CALIFORNIA COASTAL COMMISSION

Addendum

Subject: Addendum to **Item Th 19a** Coastal Commission Permit Application
#A-6-CII-08-028-E6 (Moss), for the Commission Meeting of January 14,
2016.

Figure No. VII
Job No. 07-9342

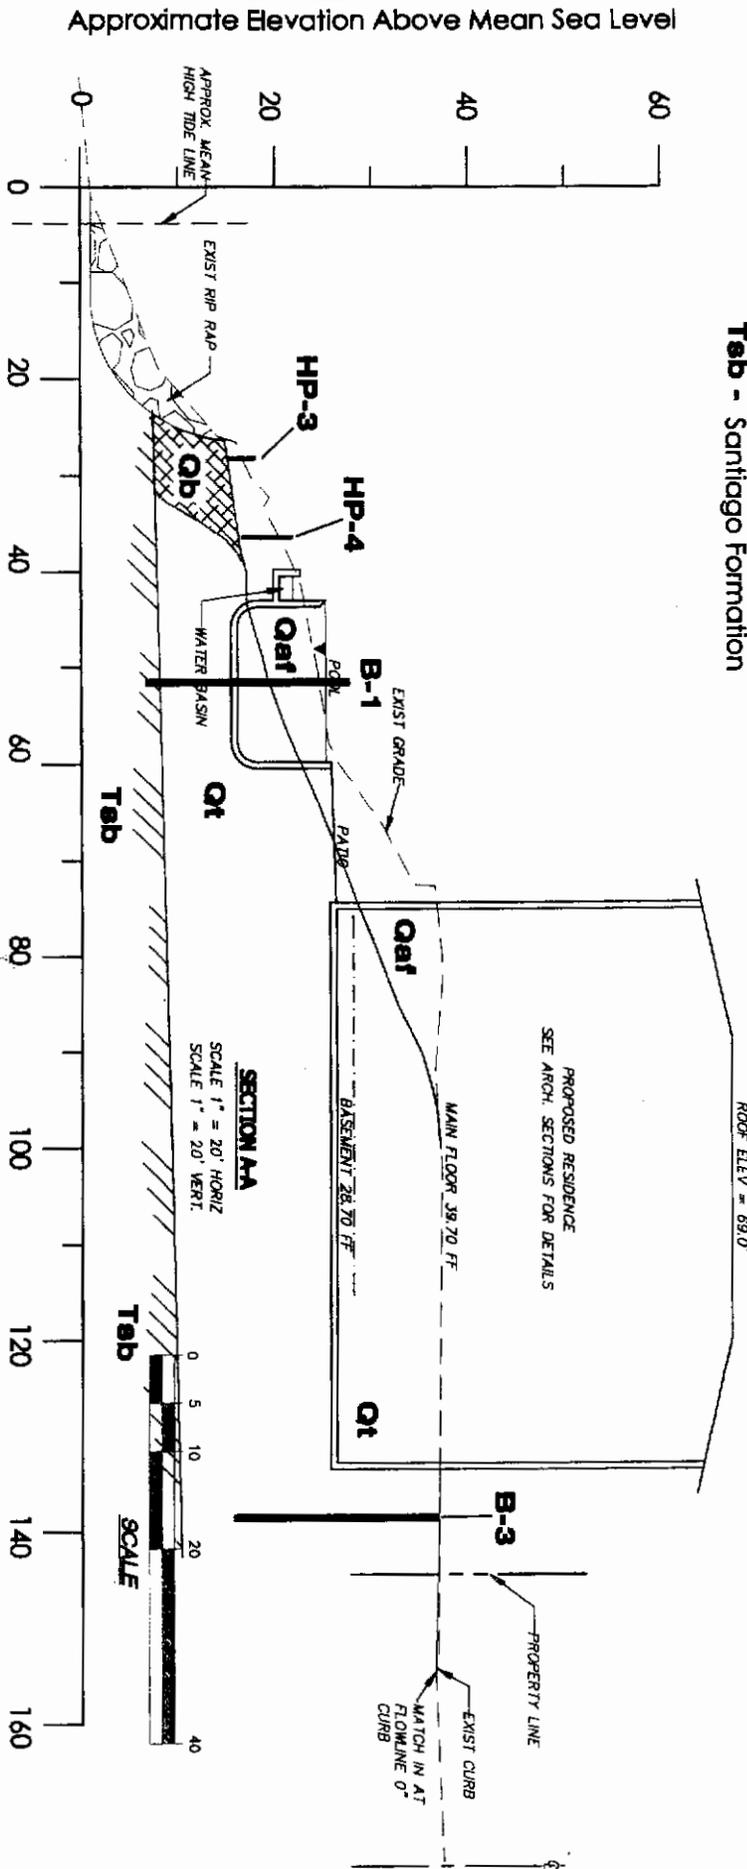
Thank you for allowing me to provide supporting information as to the variables in the sand fund calculation. I believe that 2 of the variables for Lesley's calculation are incorrect. These variables are the width of the structure (revetment) E and the "difficult to measure" v.

1. Attached please find a blow up of the geologic cross section (Moss-width.pdf). It should be noted that the actual width is arguably 10 feet but clearly no wider than 11 feet. The additional 4 feet added by coastal was actually the extension of the structure slope line or envelope NOT actual encroachment or use of beach. Rocks are not like sand they have a vertical dimension, in this case ~ 3 feet. You can count the little squares, they are 1 foot intervals.

Aerial Comparison of 20' Contour vs. 36' Contour

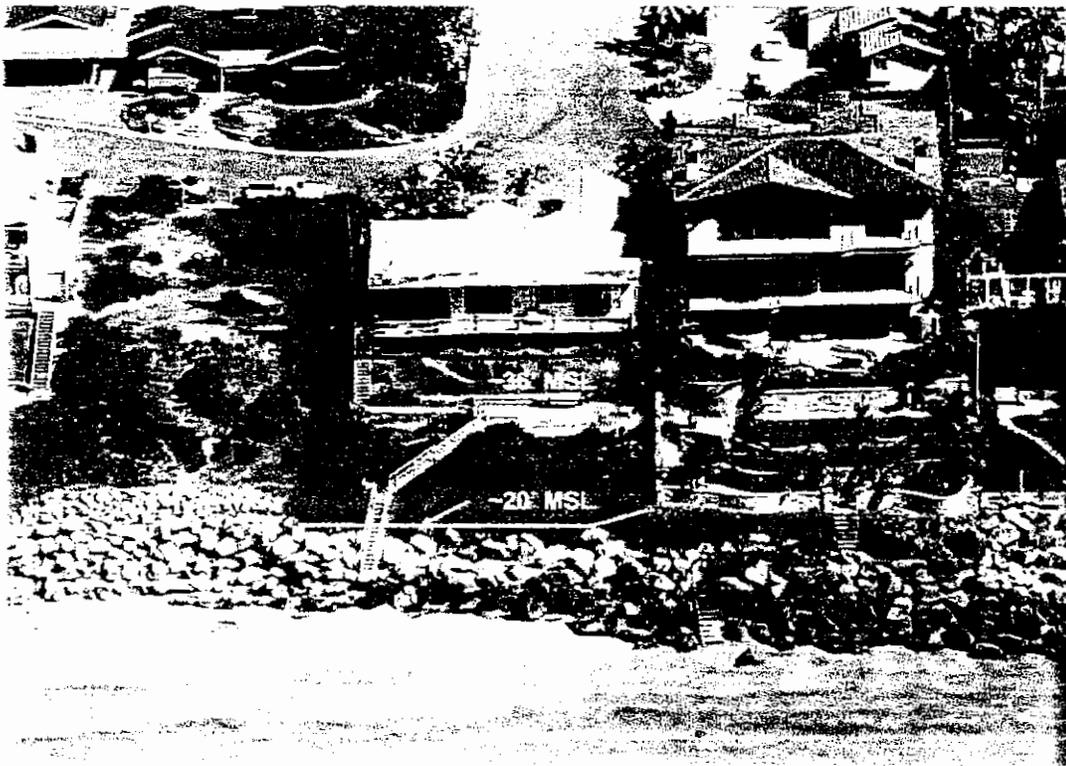
We ask that you remove Special Condition #1, which would allow the City-approved 20' contour to be applied as the bluff edge for purposes of establishing development limits and would allow the entire stairway to be retained in its current configuration. The project should be approved as proposed for the following reasons:
